SERVICE CAMPAIGN BULLETIN

CAMPAIGN REF: 037

TITLE : McLaren P1™ US Emissions Label Correction

DOCUMENT # : 12 P 001

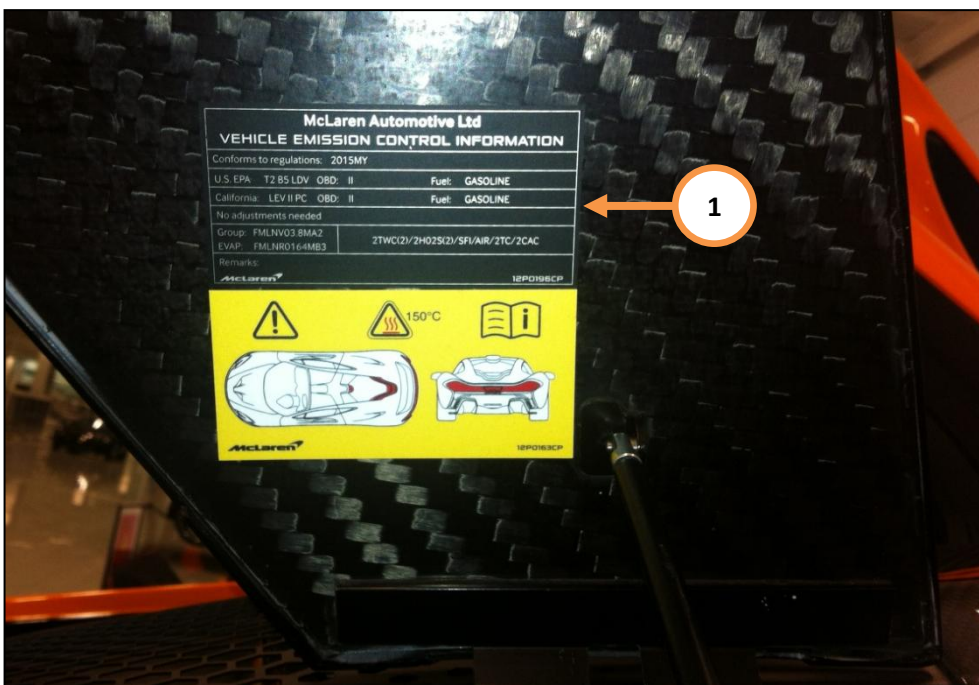
SITUATION : Quality Engineering at McLaren Automotive have identified that a number of vehicles have been fitted with VECI (US Emission) label which has a typing error on them.

1. Push down and then lift up the service tray access panel on the passenger's side of the roof.
2. Remove the existing VECI (US Emission) label (1).

PROCEDURE : It is necessary to replace the current VECI label with the new label with the correct reference on. Please follow the instructions outlined in this document.

3. Clean the surface with an alcohol cleaning solution or similar product to remove any dirt.
4. Install the new label 12P0197CP where the old label was installed.
